ADDENDUM NUMBER ONE

DARLA MOORE SCHOOL OF BUSINESS CONSTRUCTION – BP-3
ENCLOSURE/SITE/MEFP/INTERIOR
UNIVERSITY OF SOUTH CAROLINA
STATE PROJECT NUMBER H27-6069-AC-3

DATE OF ISSUE: June 04, 2012

ENLARGED FLOOR PLAN - LEVEL 1 - ADA DOOR CLEARANCES CLARIFICATION
 REF. DWG # A1110, A1110A, A1110B, A1110C, A1110D, & A1110F

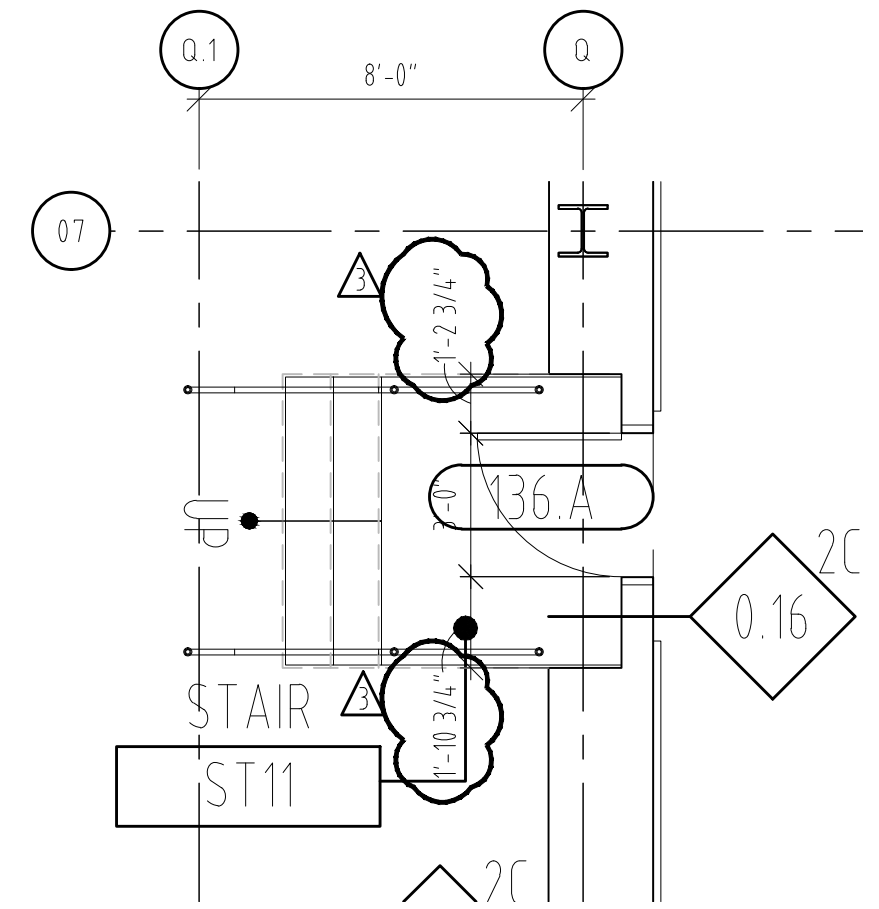
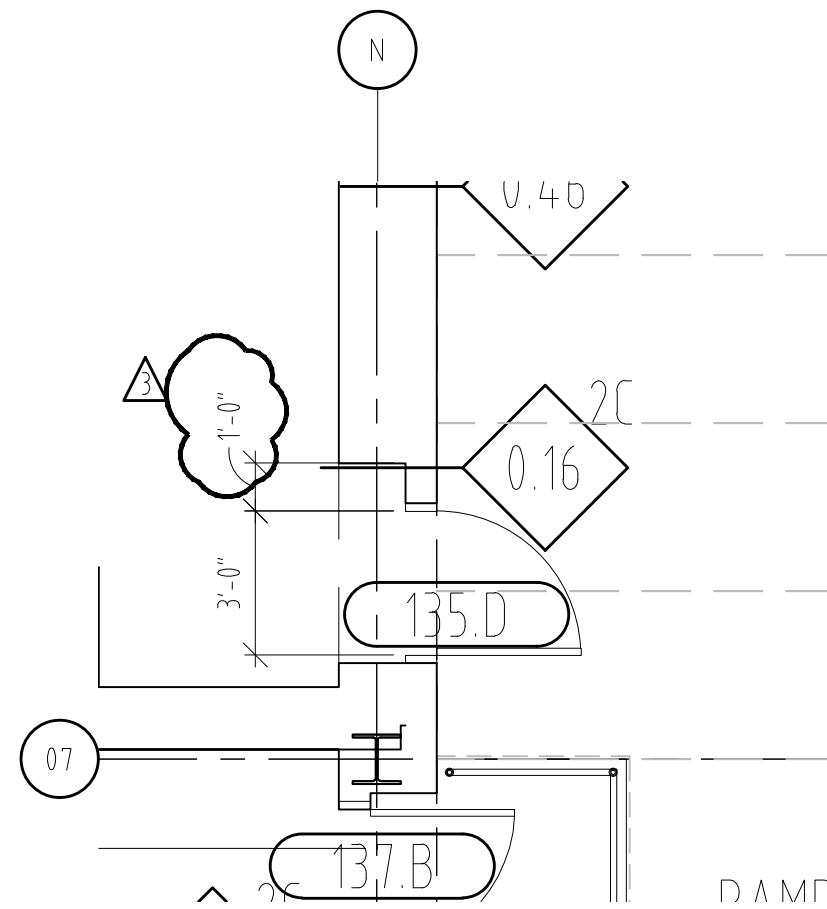
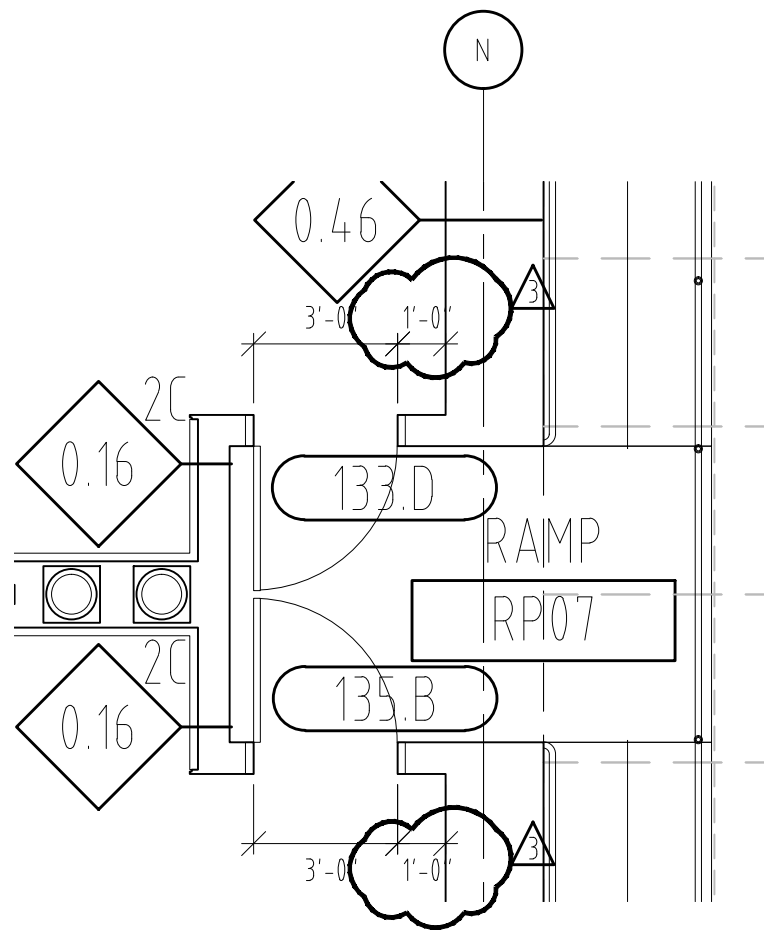
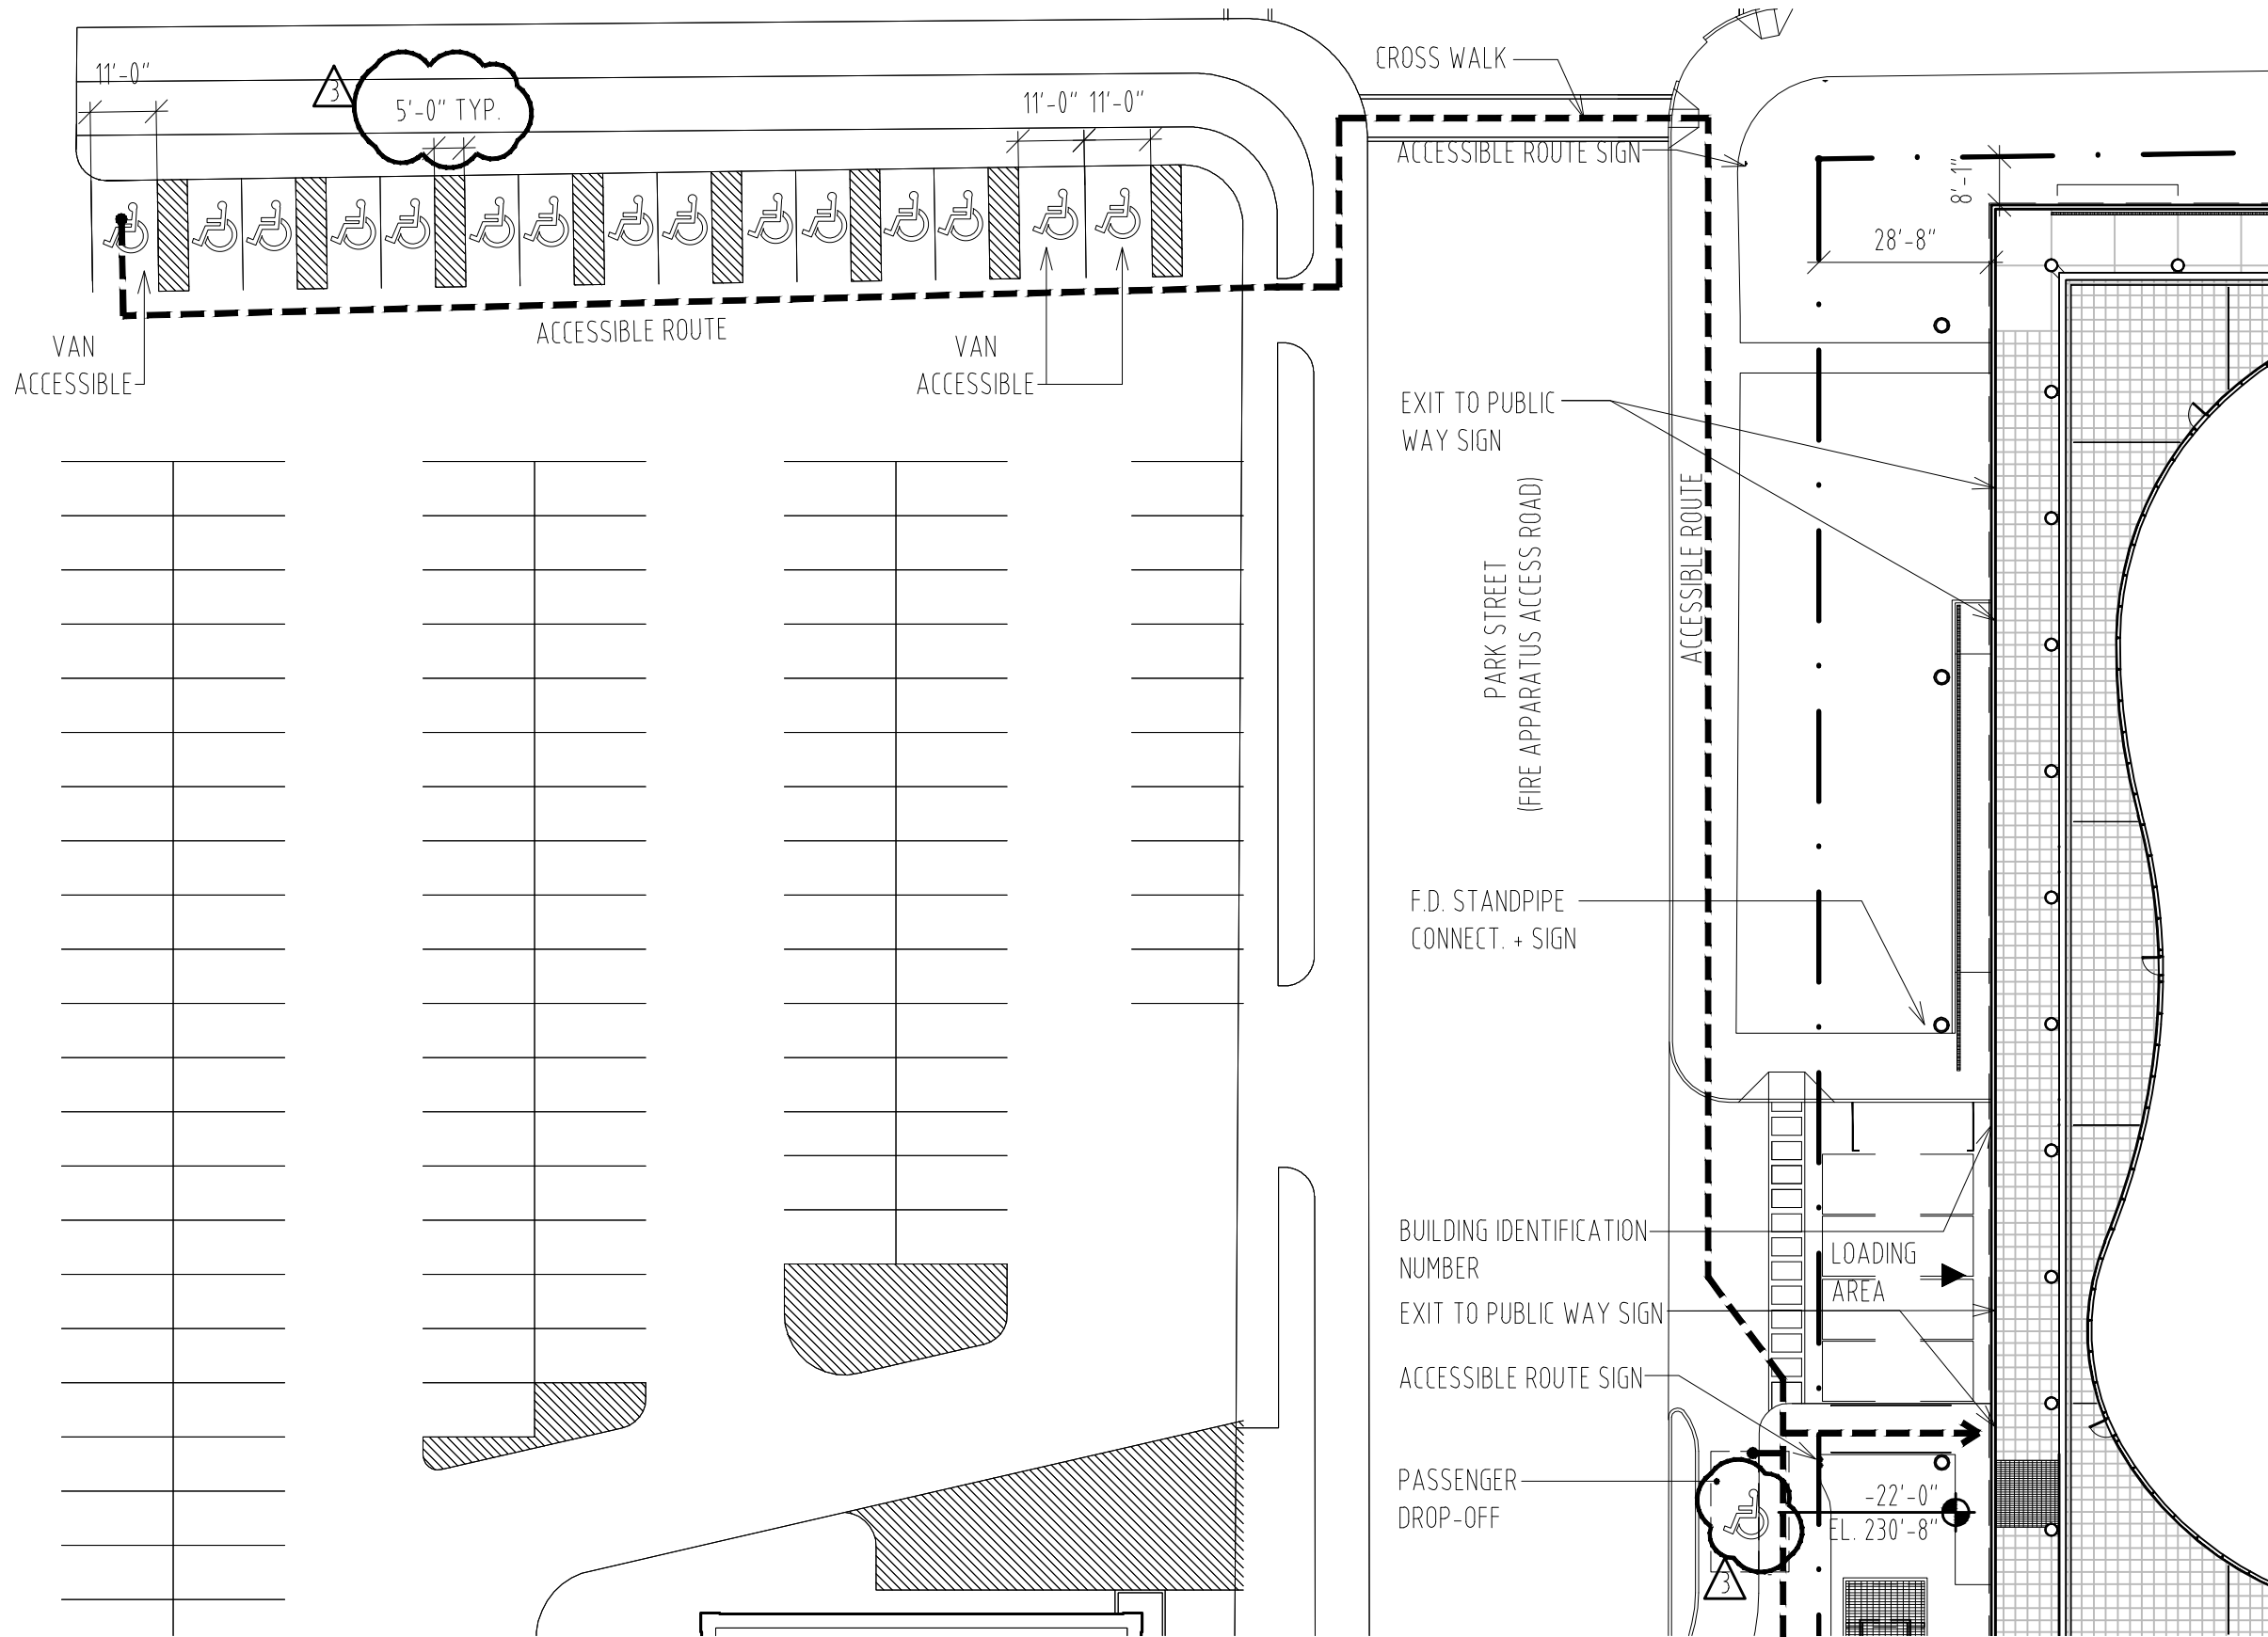
<u>Item No.</u>	<u>Description</u>
1.	Plan Sheet A5101: Refer to attached sketch A-SK-001. Dimension of accessible toilet made 5'6".
2.	Plan Sheets A1110, A1110A, A1110B, A1110C, A1110D, A1110F: Refer to attached sketch A-SK-002. Dimensional clearance clarification.

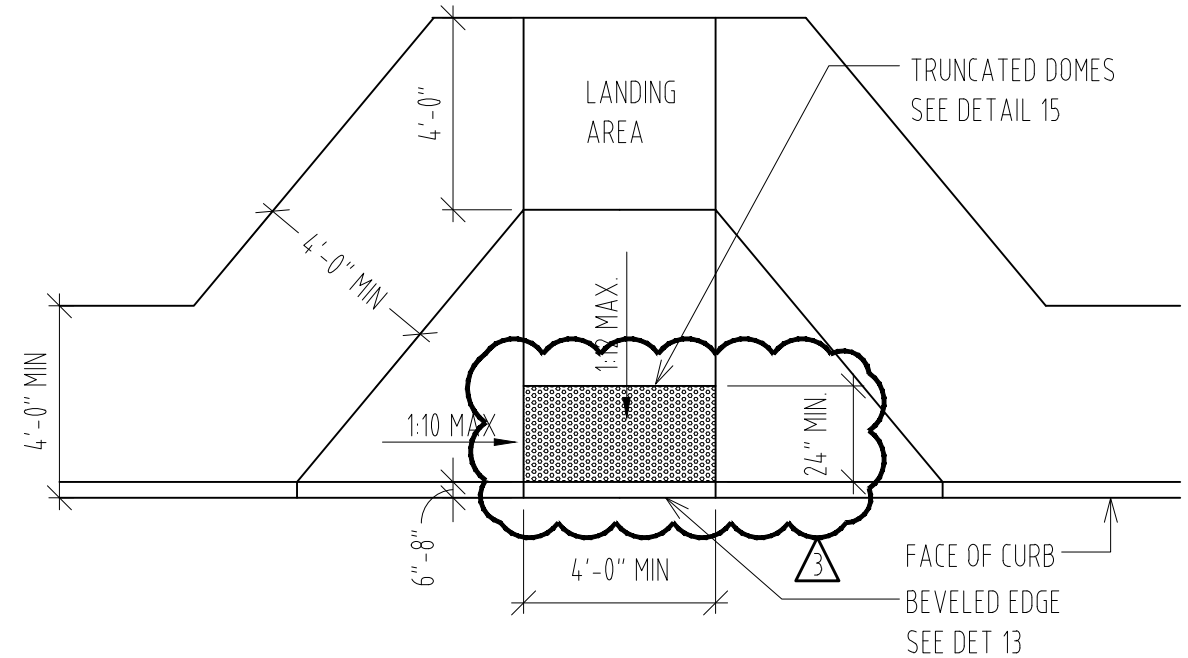
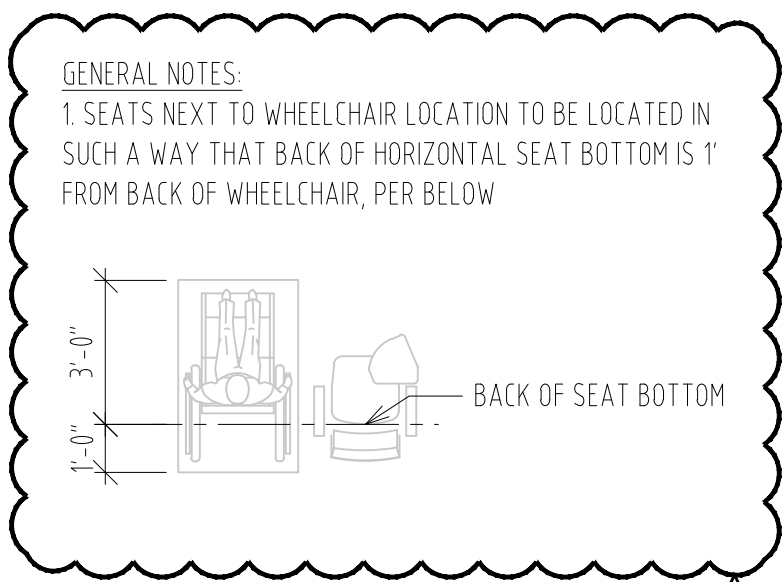
3.	Plan Sheet A0302: Refer to attached sketch A-SK-003. Accessible site parking dimension clarifications.
4.	Detail Sheet A0131: Refer to attached sketch A-SK-004. Revised location of truncated domes on site paving.
